TECHNICAL MEMORANDUM

Date: May 29, 2022

From: Jeffrey N. King, PhD PE
Principal Engineer, Applied Technology and Management

Subject: Johns Lake Minimum Flows and Levels Peer Review
Task B4: Final Peer-Review Technical Memorandum

Figure 3. Johns Lake overland flow simulation domain and simulation nodes with measured stage time series.

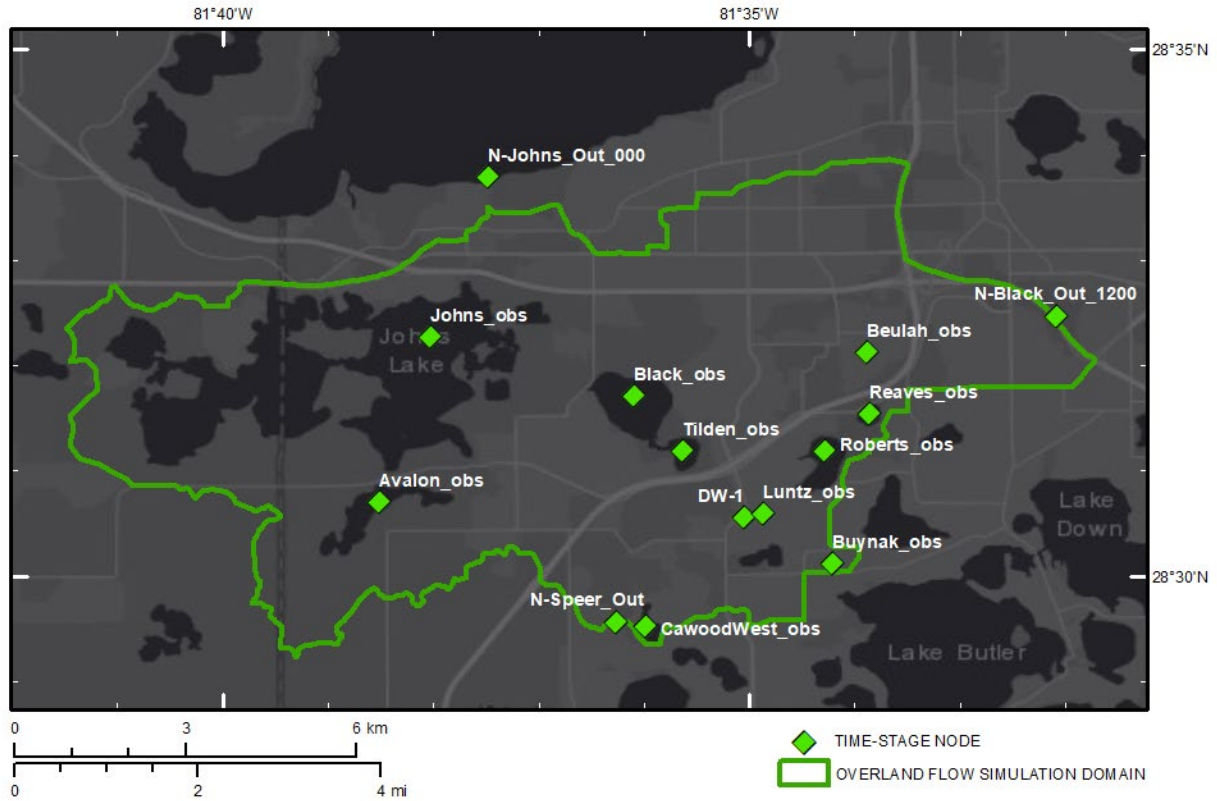
10. SJRWMD include measured lake levels in the ICPR4 simulation as time-stage nodes for the following lakes (fig. 3): Lake Avalon (fig. 4), Lake Beulah (fig. 5), Black Lake (fig. 6), Johns Lake (fig. 7), Lake Luntz (fig. 8), Lake Roberts (fig. 9), and Lake Tilden (fig. 10). SJRWMD used measured lake levels in Johns Lake for calibration and validation, and described this calibration in the associated report (Leta and others, 2021). SJRWMD also used measured lake levels in Lake Avalon (appendix 2 of Leta and others, 2021). Leta and others (2021) calculate calibration statistics for both Johns Lake and Lake Avalon (Leta and others, 2021 and appendix 2 of Leta and others, 2021). Leta and others (2021) did not describe calibration using measured lake levels for Lake Beulah, Black Lake, Lake Luntz, Lake Roberts, or Lake Tilden. Leta and others (2021) did not calculate calibration statistics for these other lakes. SJRWMD may wish to describe calibration or validation of the simulation to these other measured lake levels, including calculation of calibration statistics. Although calibration and validation of the simulation to these other lake levels may not ultimately result in significant changes to the probability distribution of simulated Johns Lake levels, the only genuine method to prove this may be to calibrate the simulation to measured levels in these other lakes and calculate calibration statistics for these other lakes.

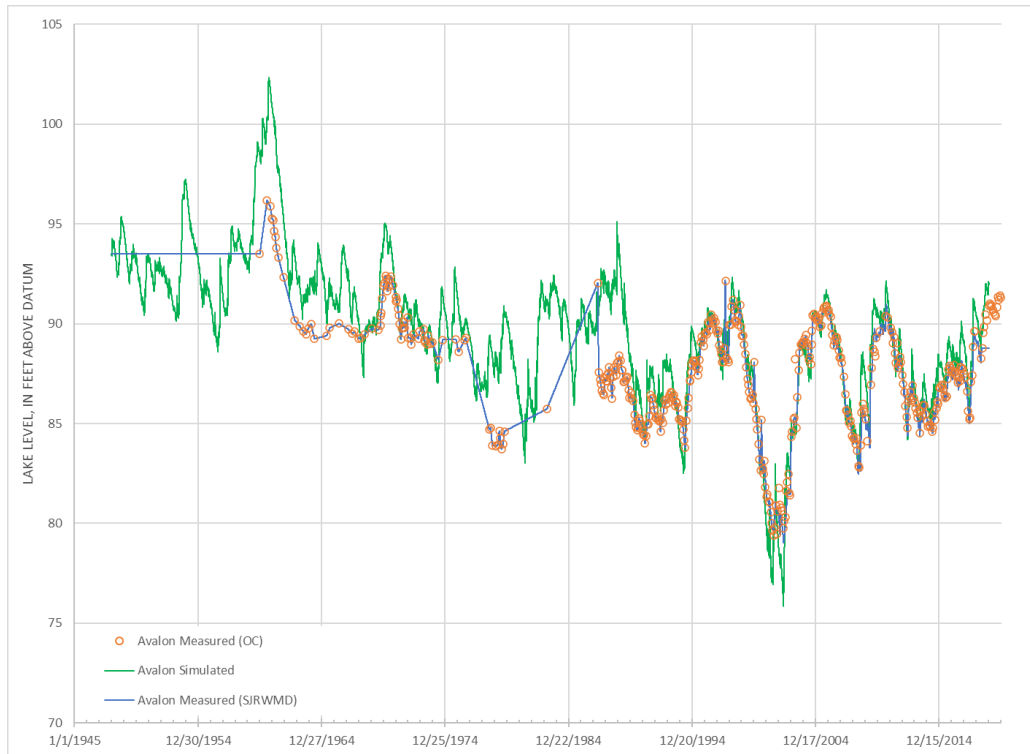
13. Calibration and validation of the simulation to measured lake levels on Lake Avalon, Lake Beulah, Black Lake, Lake Luntz, Lake Roberts, and Lake Tilden (comment 10) will improve the reliability of the simulation. Simulated lake levels do not match measured lake levels on Lake Beulah (fig. 5), Lake Luntz (fig. 8), Lake Roberts (fig. 9), or Lake Tilden (fig. 10). The simulation will be more reliable if simulated lake levels match measured lake levels on these lakes. The simulation will also be a more reliable predictor of the effect of Floridan aquifer system pumping and climate change on lake level if the simulation is capable of matching measured lake levels on these lakes. Although calibration and validation of the simulation to these other lake levels may not ultimately result in significant changes to the probability distribution of simulated Johns Lake levels, the only genuine method to prove this may be to calibrate the simulation to measured levels in these other lakes and calculate calibration statistics for these other lakes.

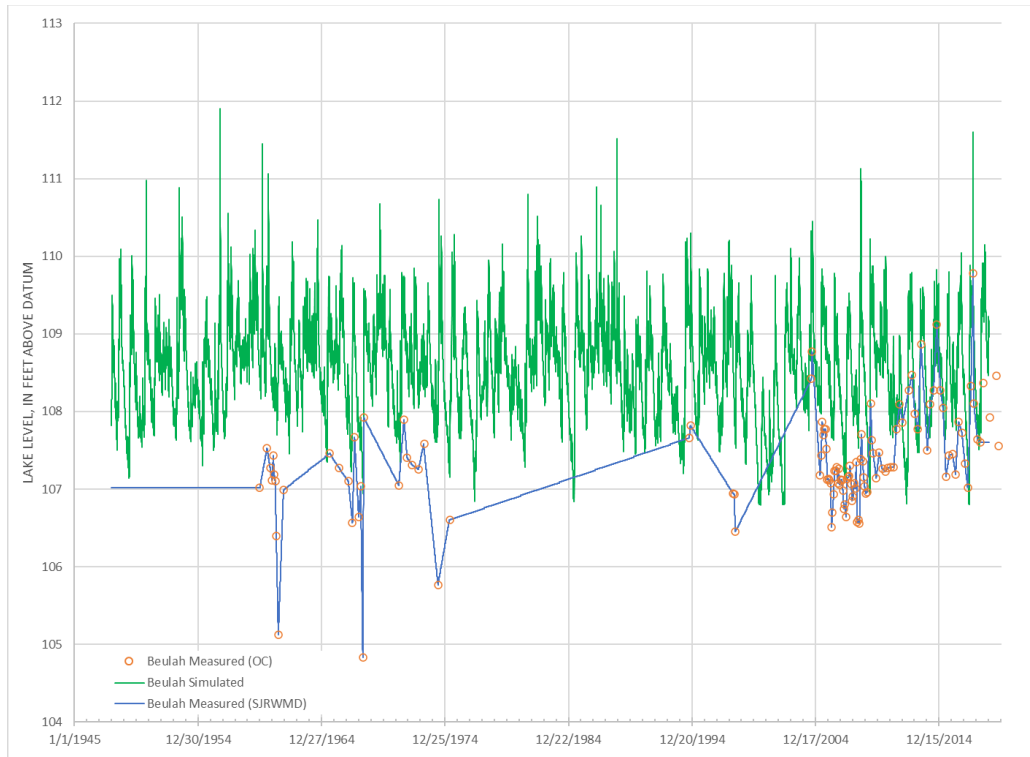
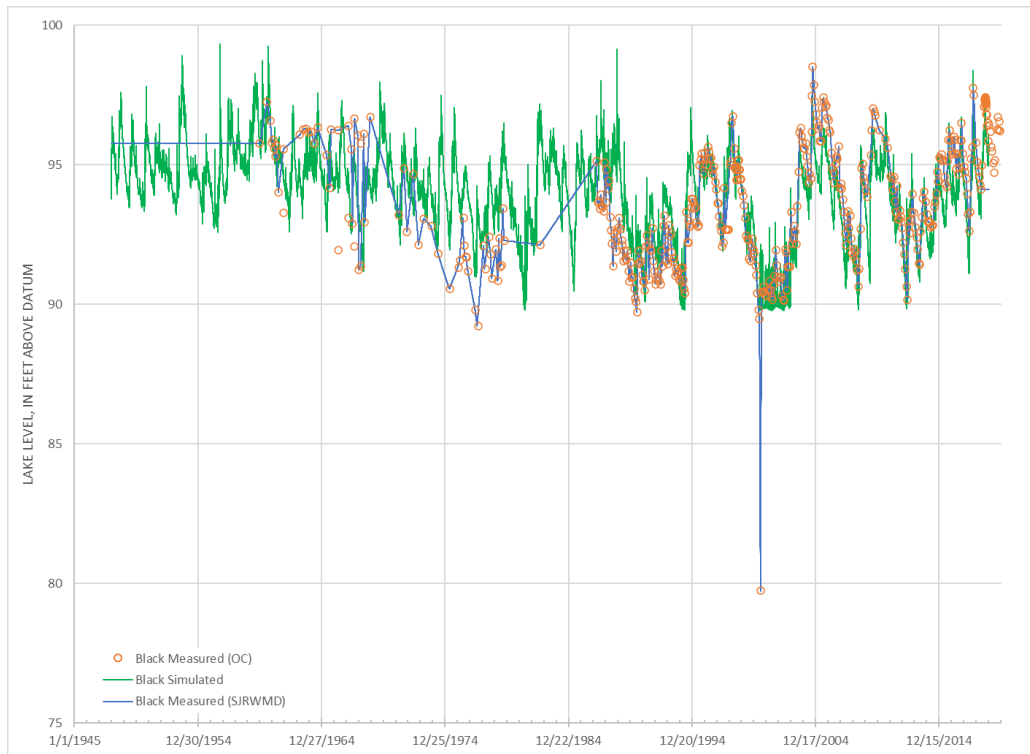
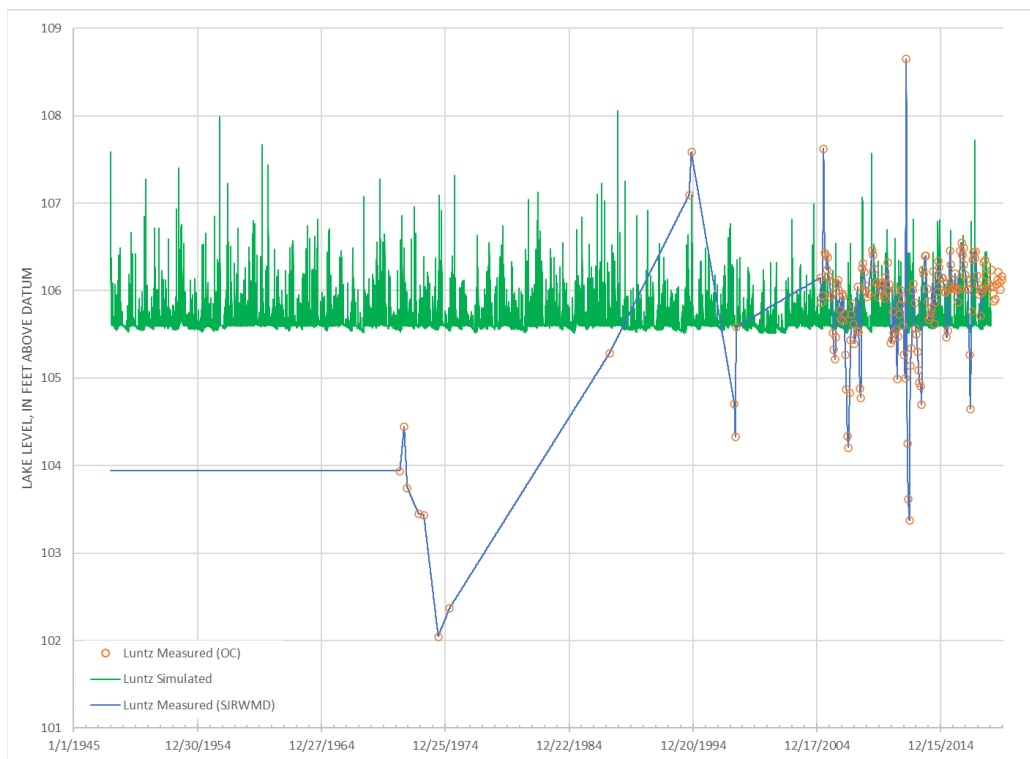
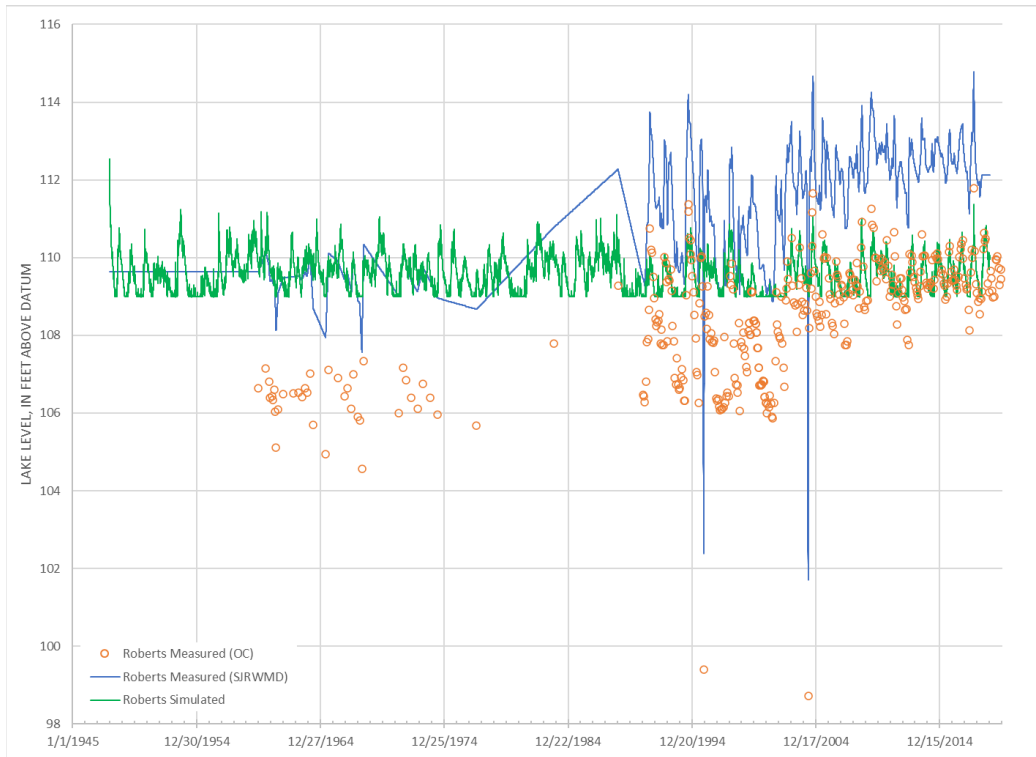
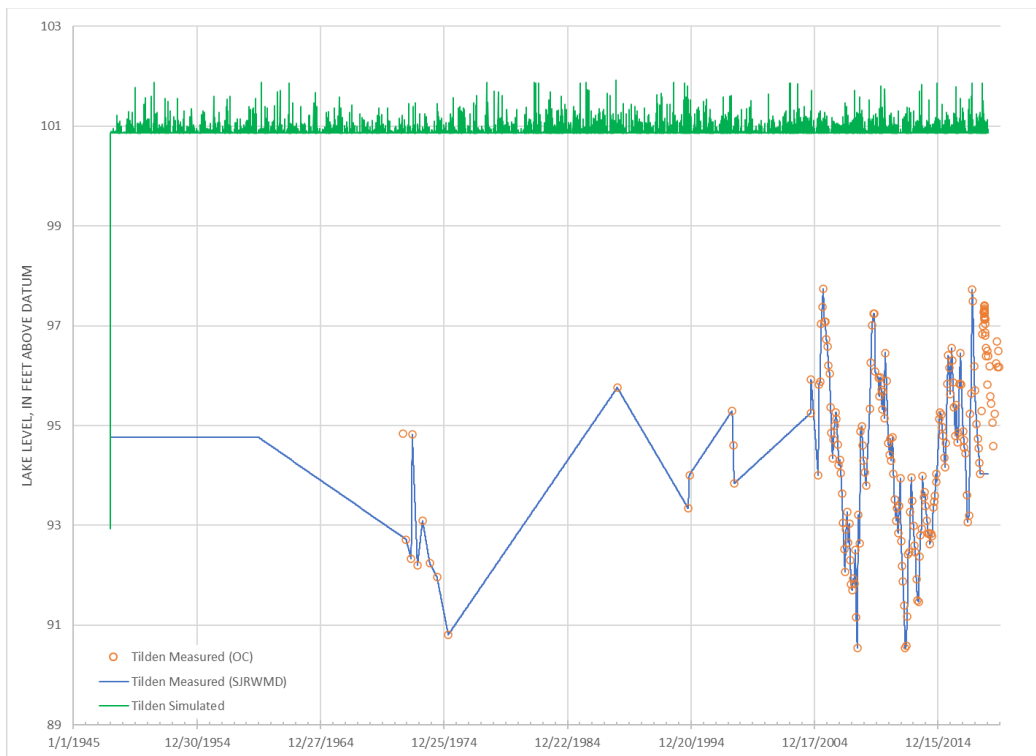
SJRWMD did not use bathymetric elevations for Beulah Lake, Black Lake, Luntz Lake, Roberts Lake, Tilden Lake, and Yarbo Lake. Although the major objective of this ICPR4 simulation is to quantify a minimum Johns Lake level, necessary to satisfy rule 62.40, the importance of benthic discharge flux to Johns Lake and benthic recharge flux from Johns Lake on lake level requires accurate representation of the hydraulic gradient from Johns Lake to these other lakes. Lake level in Lake Luntz (fig. 8), Lake Roberts (fig. 9), and Lake Tilden (fig. 10) is not

simulated below a minimum elevation for each lake, which is greater than measured lake levels on these lakes. This failure to simulate minimum levels in these lakes is likely due to an absence of stage-volume information below a lake level in the digital elevation model.

11. SJRWMD included measured lake levels in the ICPR4 simulation as time-stage nodes (plotted on Figure 4 through Figure 10 as blue polylines). Liquid Solutions Group—as consultants to Orange County Stormwater Management Division—provided SJRWMD with measured lake levels following the April 6, 2022, public teleconference (also plotted on Figure 4 through Figure 10, as orange points). SJRWMD time-stage lake levels appear to match Liquid Solutions Group lake levels for all lakes, except Lake Roberts. SJRWMD may wish to determine which set of Lake Roberts levels are correct.

SJRWMD may wish to revise the simulation to incorporate lake-bed elevations for other lakes. SJRWMD may choose to measure lake-bed elevation; or SJRWMD may make reasonable assumptions about lake-bed elevations from an assumed maximum lake depth and an assumed lake bed geometry, and to document these reasonable assumptions in the report that describes the simulation. Simulations are abstract representations of more complex systems. Although crude, some hydrologists will accept an assumed maximum lake depth and assumed lake bed geometry as an acceptable, abstract representation.

Figure 11. Examples of simulation links with initial conditions that result in relatively greater rates of change for flow than during other periods in the flow time series at (A) link C-Johns_Out_170A and (B) link C-Reaves_000.

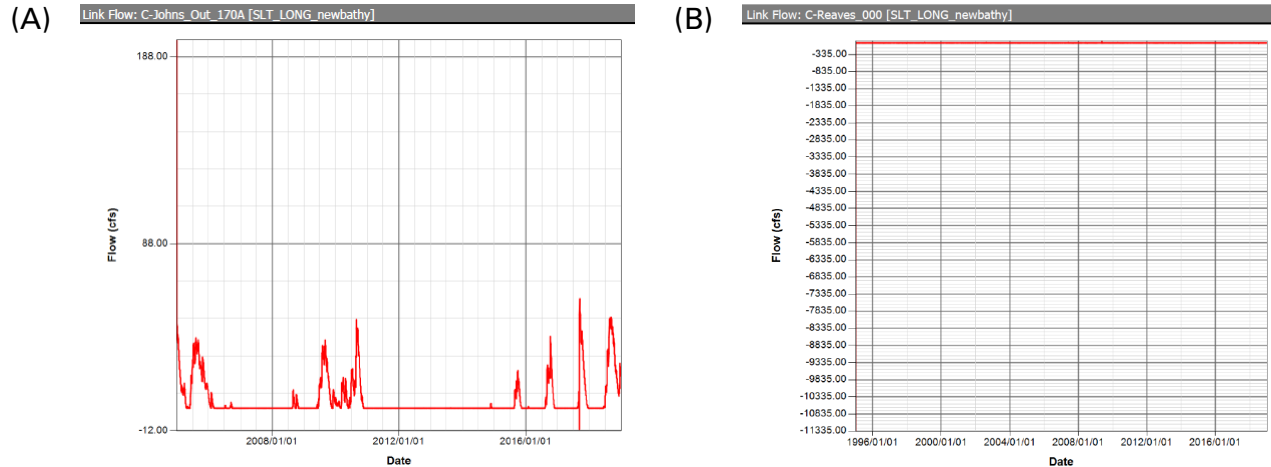
29. Instabilities: The initial condition in the following links results in relatively greater rates of change for flow than during other periods of the flow time series: C_Johns_000C, C-Black_600, C-Reaves_000 (fig. 11B), C-Johns_Out_140, and C-Johns_Out_170A (fig. 11A). SJRWMD may wish to build a hot start initial condition that does not result in relatively greater rates of change for flow than during other periods of the flow time series, for all links in the simulation. Ideally, a time series for flow should change gradually from an initial condition, for all links in the simulation. SJRWMD may wish to avoid abrupt changes in flow immediately after the simulation commences, throughout the simulation.

Figure 12. Examples of simulation node (N-Tilden_100) with initial conditions that result in relatively greater rates of water-surface elevation change than during other periods of the flow time series.

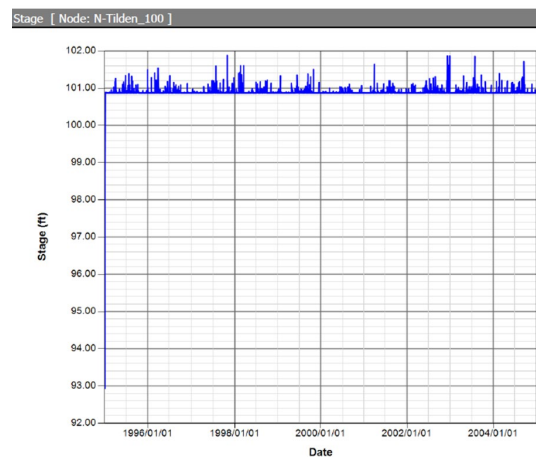
30. **Instabilities:** The initial condition for stage at the following nodes results in a relatively greater rate of water-surface elevation change than during other periods of the stage time series: N-Johns_000_A, N-Tilden_100 (fig. 12). SJRWMD may wish to build a hot start initial condition that does not result in relatively greater rates of water-surface elevation change than during other periods of the flow time series, for all nodes in the simulation. Ideally, the time series for water-surface elevation should change gradually from an initial condition, at all nodes in the simulation. SJRWMD may wish to avoid abrupt changes in water-surface elevation immediately after the simulation commences, throughout the simulation.

Figure 13. Example of simulation link (C-Black_020B_C) with a relatively greater rate of change for flow in late 2017 than during other periods of flow time series.

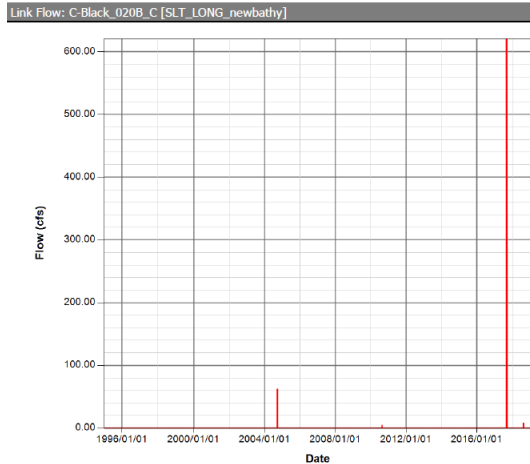
31. **Instabilities:** The following links exhibit relatively greater rates of change for flow than during other periods of flow time series; or possibly oscillation, in which flow rate changes rapidly and repeatedly from positive to negative over a relatively short duration: C_Black_020B_C, C_Black_120C (fig. 13), C_Black_710B, C-Black_600, and C-Black_200. SJRWMD may wish to physically justify these changes in flow or oscillatory behavior, or use simulation strategies, such as damping, to diminish these rates of flow change.

Photograph 7. The downstream side of a water control structure that once regulated the flow of water from the Johns Lake watershed to a ditch that drains to Lake Apopka, on the southeastern bank from 28° 33' 5.9" N 81° 37' 12.8" W, looking southwest toward West Colonial Drive on March 3, 2022.

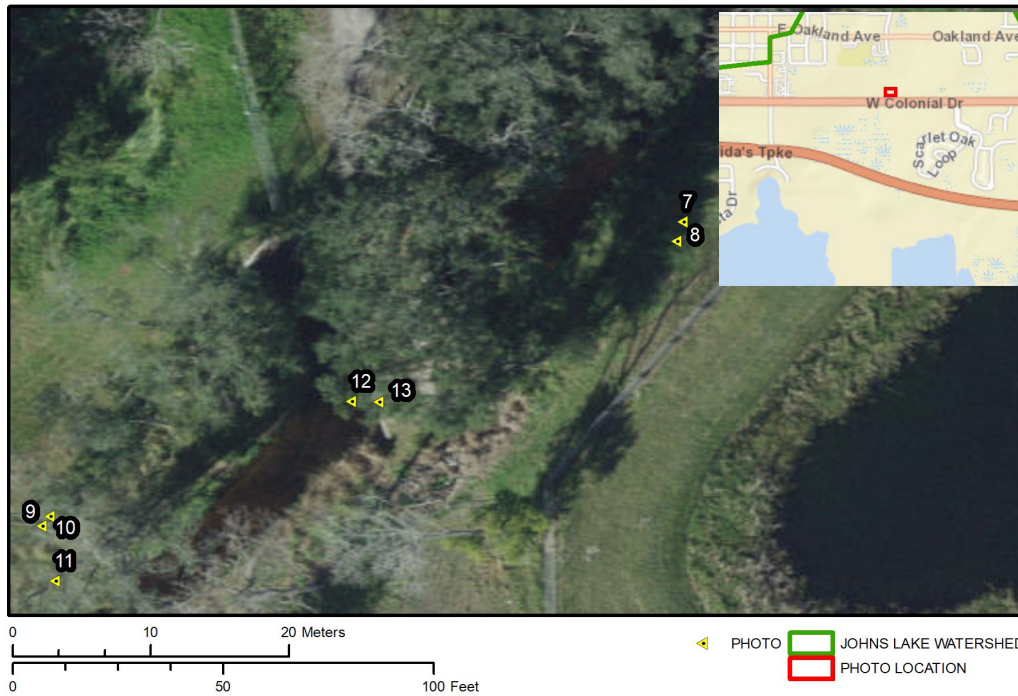
7. John Schmidt, President, Johns Lake Association, asked in the April 6 teleconference whether SJRWMD simulated the water control structure near West Colonial Drive (photograph 7, photograph 8, photograph 9), and the influence of this water-control structure on flow from the Johns Lake watershed to Lake Apopka. Leta and others (2021) state that “larger discrepancy between the long-term observed and simulated stages is noticed before 1993, a period when significant urbanization had not occurred or considered as a pre-development period. The decrease in model performance during this period could be due to additional uncertainties attributed by ... significant land use/land cover developments of the watershed.” SJRWMD simulated contemporary land use. SJRWMD also simulated structure elevations and structure geometry for a water control structure near West Colonial Drive (photograph 7, photograph 8, photograph 9), which controls the flow of water from Johns Lake to Lake Apopka; and channel roughness near this water control structure (photograph 8, photograph 12, and photograph 19).

SJRWMD may choose to revise the simulation to incorporate transient land use based on available historical aerial photographs. The University of Florida manages an archive of aerial photographs that detail Johns Lake and surrounding areas, with photographic mosaics from 1941, 1947, 1954, 1958, and 1974. SJRWMD maintain GIS shapefiles for land use in 1973, 1984, 1990, 1994, 1999, 2004, 2009, and 2014.
